ICE AND RAIN PROTECTION - CHANGE ANTI-ICE CROSSFLOW VALVE ORIENTATION

Studs on the anti-ice crossflow valve can rub against the fuselage and cause damage.

This service document provides parts and instructions to change the orientation of the anti-ice crossflow valve to prevent it from rubbing on the fuselage.

SB680A-30-01
Page 1 of 6

Figure 1. Wing Crossover Anti-Ice Valve Bracket (Sheet 1)

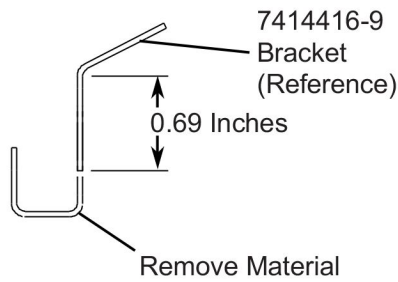
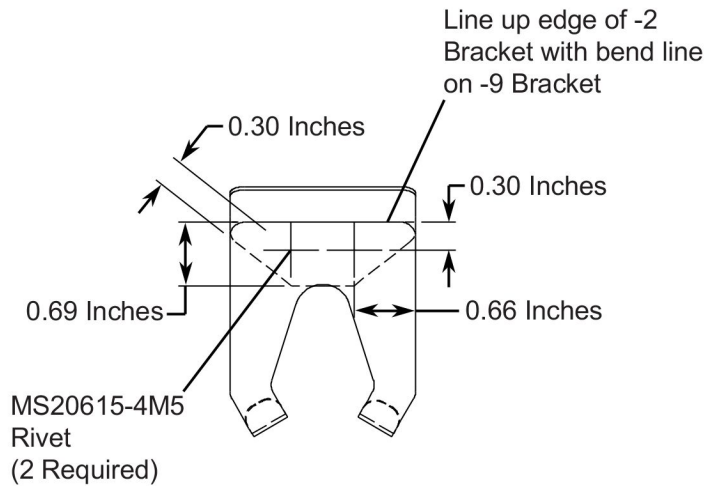
3. (Refer to Figure 1, Sheet 1.) Modify the 7414416-9 Bracket.
 - A. Measure 0.69 inches down from the bend radius on the 7414416-9 Bracket and remove the material as shown.

- B. Attach the 7490009-2 Bracket behind the 7414416-9 Bracket.
 - C. (Refer to Figure 1, Sheet 1.) Mark the hole locations as shown.
 - D. Drill the 0.125 inch holes.

- E. Deburr the drilled holes.
 - F. Install the MS20615-4M5 Rivets.
 - G. Clean and remove any debris from the area.

Figure 1. Wing Crossover Anti-Ice Valve Bracket (Sheet 2)

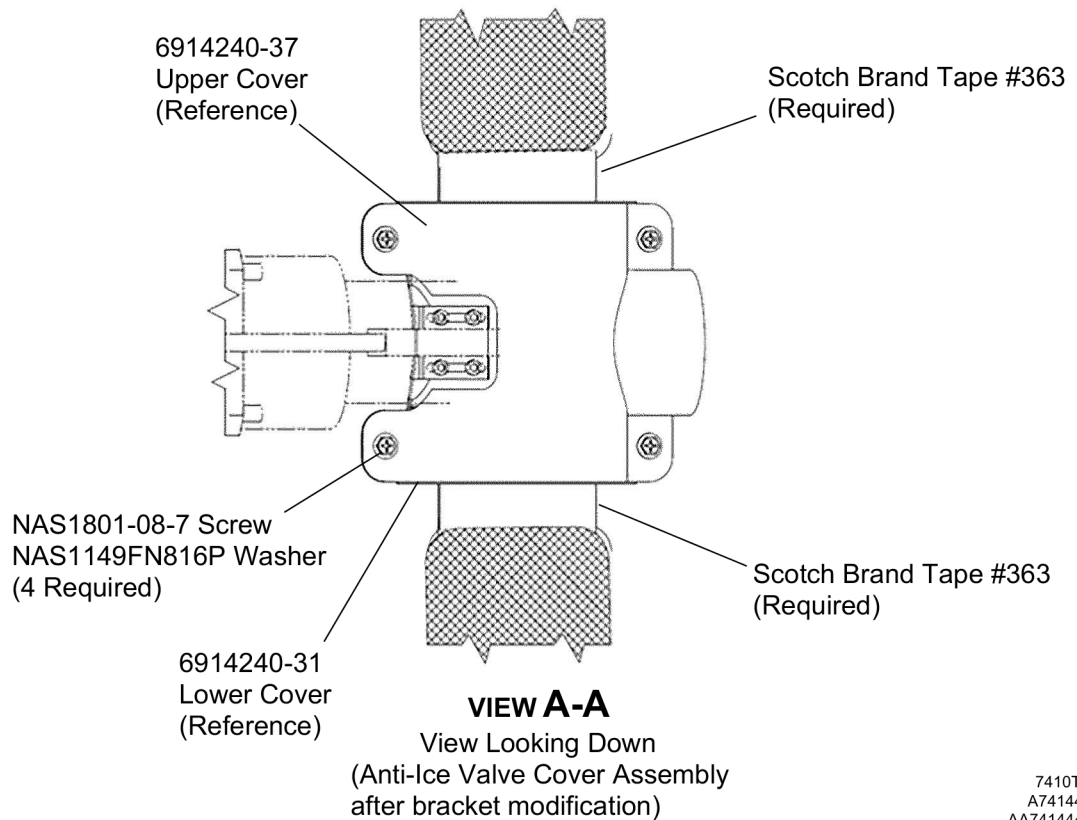
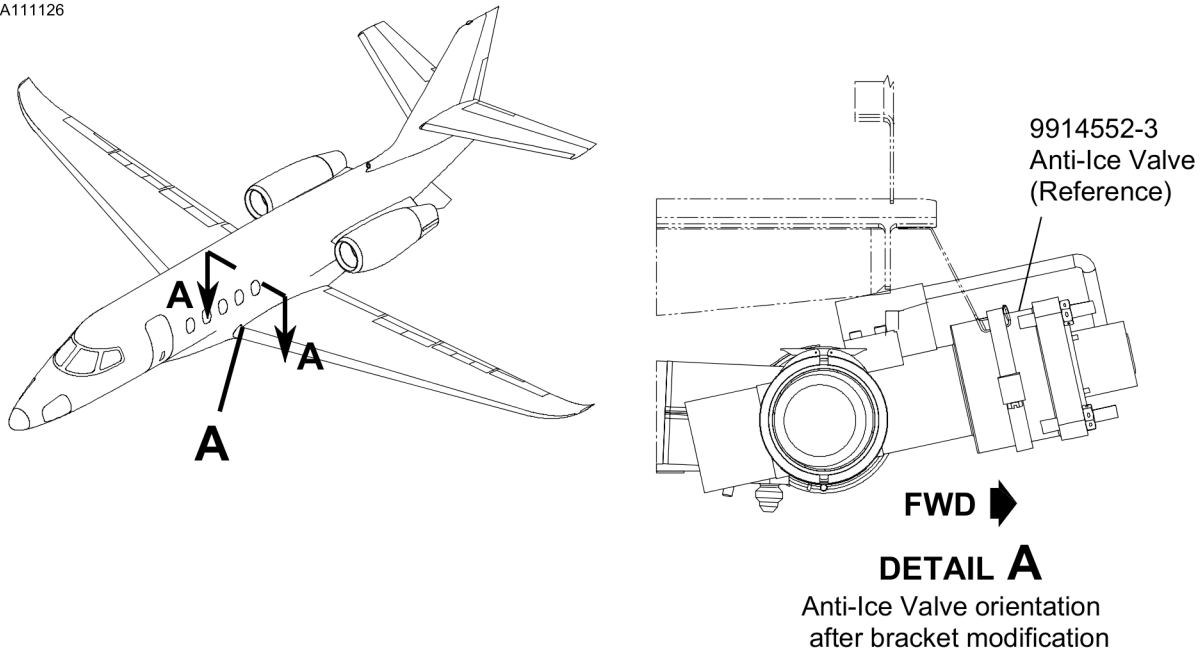
4. Inspect the fuselage skin and repair as necessary. (Refer to the Model 680A Structural Repair Manual, Chapter 51, Crack, Scratch, Gouge and Corrosion.)
5. (Refer to Figure 1, Sheet 2.) Install the 9914552-3 Wing Anti-Ice Crossflow Valve as shown. (Refer to the Model 680A Maintenance Manual, Chapter 30, Wing Anti-Ice Crossflow Valve - Removal/Installation.)

NOTE: The valve orientation has changed.

NOTE: The cover orientation has changed.

- A. Install the wing anti-ice valve cover with the four NAS1801-08-7 screws and NAS1149FN816P Washers as shown.

- B. Wrap the tubing with the Scotch Brand Tape #363 Glass Cloth Tape in the areas shown to seal any gaps between the tube and cover.
6. Modify the 9914552-3 Wing Anti-Ice Crossflow Valve connector PY023 wiring.
 - A. Disconnect electrical connector PY023 from the 9914552-3 Wing Anti-Ice Crossflow Valve (if necessary).
 - B. Remove Pin A from connector PY023.
 - C. Cut the contact off the wire.
 - D. Use one M81824/1-1 Splice to splice on approximately 9 inches of M81044/12-22-9 Wire marked (69600-3001-H24A-22) APY023-(SP)APY023.
